ITEM #: 27a  
DATE: 11-15-16

### COUNCIL ACTION FORM

**REQUEST: MAJOR SITE DEVELOPMENT PLAN FOR 2041 COTTONWOOD ROAD**

**REQUEST: MAJOR SITE DEVELOPMENT PLAN FOR 2105 COTTONWOOD ROAD**

# Attachment A- Landscape Plan

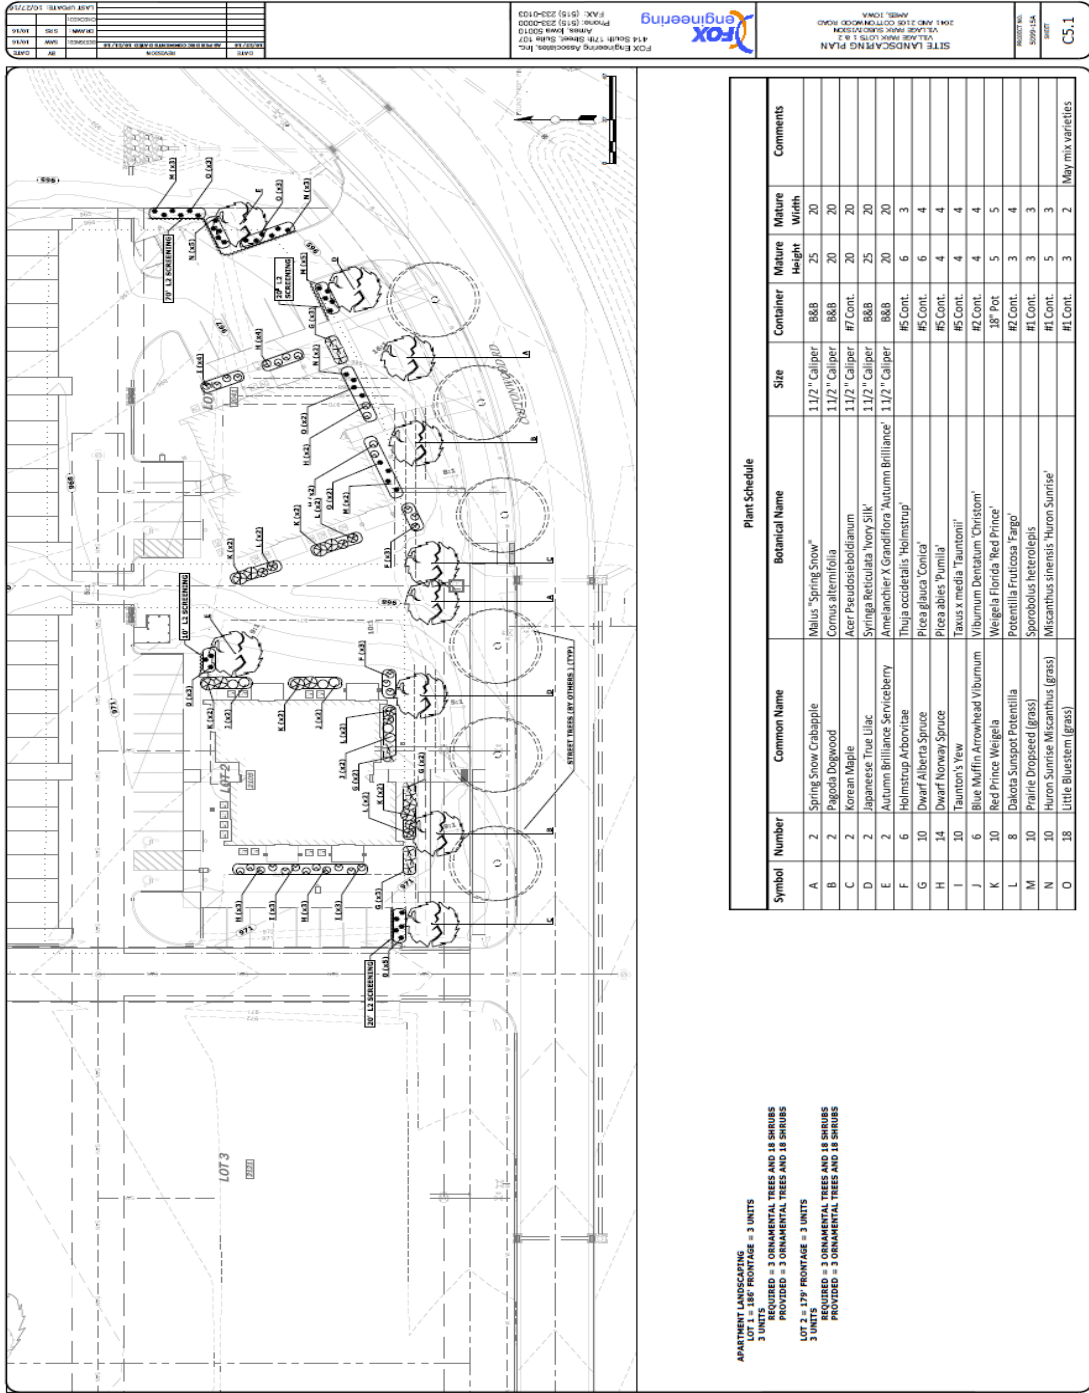
Landscape standards require the installation of building foundation screening along the street frontage of an apartment building as well as screening located between the parking area and property lines. As currently configured, the developer seeks approval of alternative parking lot landscaping (29.403(4)(d)) for two issues. The first is to allow substitution of ornamental grasses in lieu of shrubs. The second is to not require screening along the edge parking area on the west side of the site. The developer would be required to plant additional trees and shrubs along the west edge of the site to comply with standard requirements.

The developer believes that the grasses provide a desirable aesthetic to the project and provide for a suitable level of screening. Grasses during the summer months provide effective screening, but in the winter months there is likely no screening as the grasses are cut to allow them to regrow in the spring. In this situation staff believes they are acceptable due to the low sensitivity of other uses abutting the site. The developer believes the 2<sup>nd</sup> issue of edge landscaping is also unnecessary along the west property line due to the abutting use of parking at the property line. The screening is likely not a substantial issue of compatibility, but an additional tree could be included to meet the intent of the shading over parking areas. This is a similar request that is part of all four proposed project along Cottonwood.

The street frontage foundation landscaping must be a combination of plantings as described in Section 29.403(6)(b). The groupings of foundation plants are referred to as Landscape Units and their quantities specified to meet this requirement. Specifically, there must be trees and 6 deciduous and evergreen shrubs planted for every 60 feet of street frontage. The total frontage at this site is 186 feet. The developer has included appropriate trees, but has not included shrubs as they desired to use grasses. In this instance, the foundation planting must meet the specified planting quantity and substituting grasses is not permitted. A condition is included to revise the landscaping with 8 additional deciduous or evergreen shrubs to be planted along the street frontage side of the building. The proposed grasses can stay in place but shrubs must be added to meet the required plantings for street frontage foundation landscaping.

- D. The landscape plan shall be revised to include front yard foundation planting landscaping units compliant with the zoning ordinance standards of Section 29.403(6) of the Municipal Code, this include revisions to the tree configuration of the landscape unit and for eight additional foundation planting shrubs.

# Attachment A- Landscape Plan (cont.)

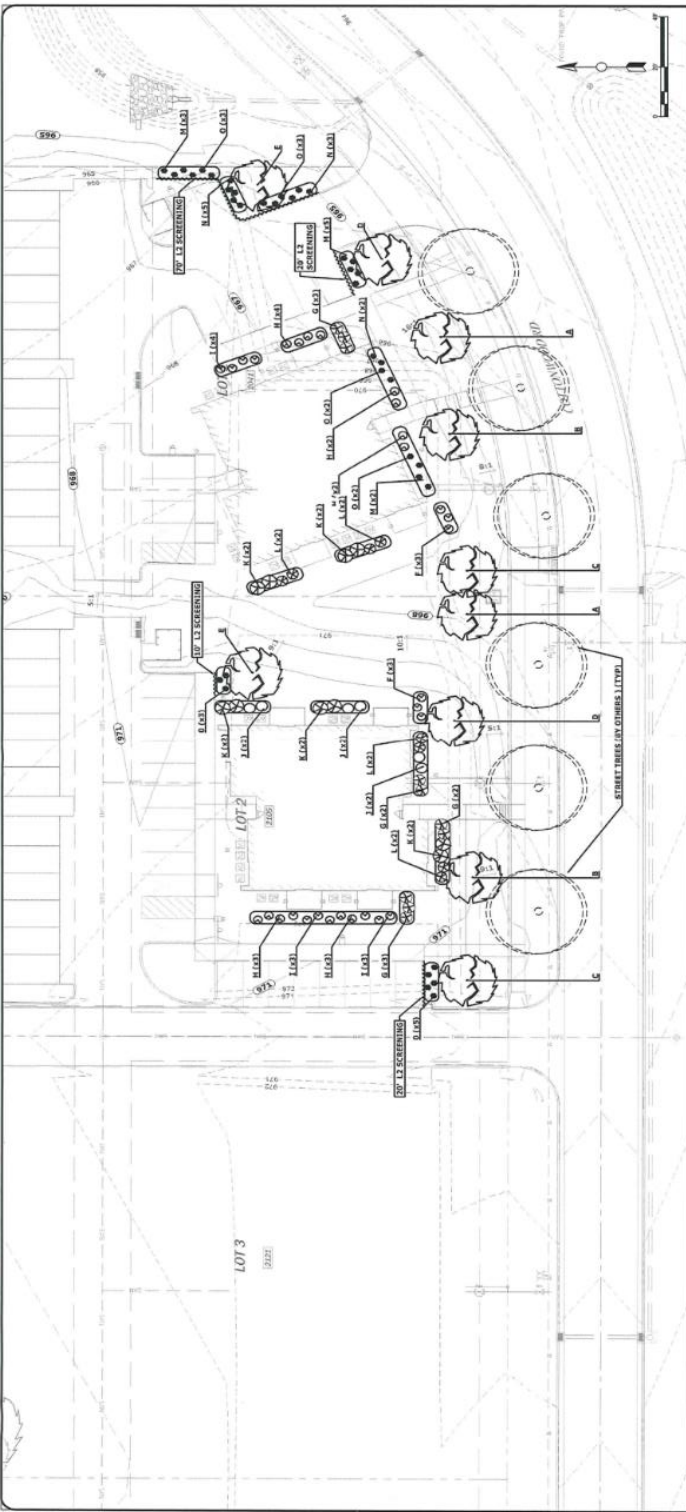
Landscape standards require the installation of building foundation screening along street frontage of an apartment building as well as screening located between the parking area and property lines. As currently configured, the developer seeks approval of alternative parking lot landscaping (29.403(4)(d)) for two issues. The first is to allow substitution of ornamental grasses in lieu of shrubs. The second is to not require screening along the edge parking area on the west side of the site. The developer believes that the grasses provide a desirable aesthetic to the project and provide for a suitable level of screening. Grasses during the summer months provide effective screening, but in the winter months there is likely no screening as the grasses are cut to allow them to regrow in the spring. In this situation staff believes they are acceptable due to the low sensitivity of other uses abutting the site. The developer believes the 2<sup>nd</sup> issue of edge landscaping is also unnecessary along the west property line due to the abutting use of parking at the property line. The screening is likely not a substantial issue of compatibility, but an additional tree could be included to meet the intent of the shading over parking areas.

Due to the shared driveway between this lot (Lot 2) and the neighboring lot to the west (Lot 3) no perimeter parking landscaping is provided along the west side of the property between the parking to the west of the building and lot 3. The developer would otherwise be required to plant additional trees and shrubs along the west edge of the site to comply with standard requirements. This is a similar request that is part of all four proposed project along Cottonwood.

The street frontage foundation landscaping must be a combination of plantings as described in Section 29.403(6)(b). The groupings of foundation plants are referred to as Landscape Units and their quantities specified to meet this requirement. Specifically, there must be trees and 6 deciduous and evergreen shrubs planted for every 60 feet of street frontage. The total frontage at this site is 186 feet. The developer has included appropriate tree and shrub quantities to meet the standard.

- D. The landscape plan shall be revised to include front yard foundation planting landscaping units compliant with the zoning ordinance standards of Section 29.403(6) of the Municipal Code, this include revisions to the tree configuration of the landscape units.
2. The City Council can approve the Major Site Development Plan for the proposed apartment building with modifications.
  3. The City Council can deny the Major Site Development Plan for the proposed apartment building if it finds the project does not meet the Major site Development Plan criteria.
  4. Action on this request can be postponed and referred back to City staff and/or the applicant for additional information.
